# Service Bulletin

Bulletin No.: 19-NA-128

**Subject: Limited Vehicle Speed, Malfunction Indicator Lamp (MIL) Illuminated - DTC P07A7**

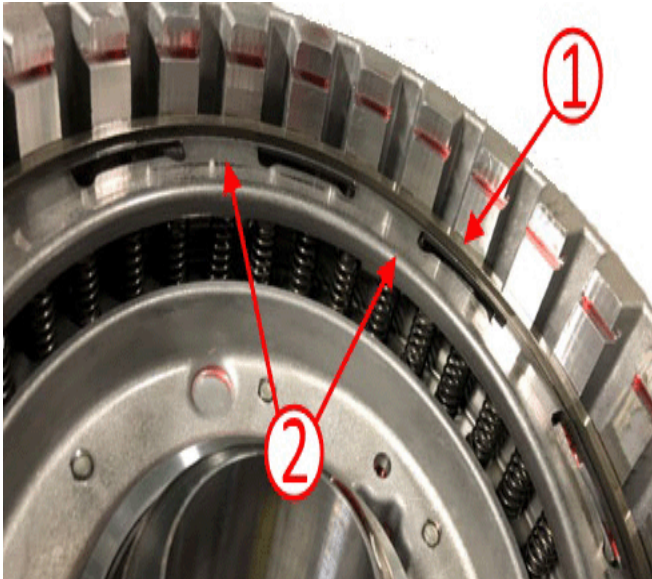
**Important:** During assembly, position the 1-3 clutch return spring ring as shown in the attached picture to aid in retainer installation.
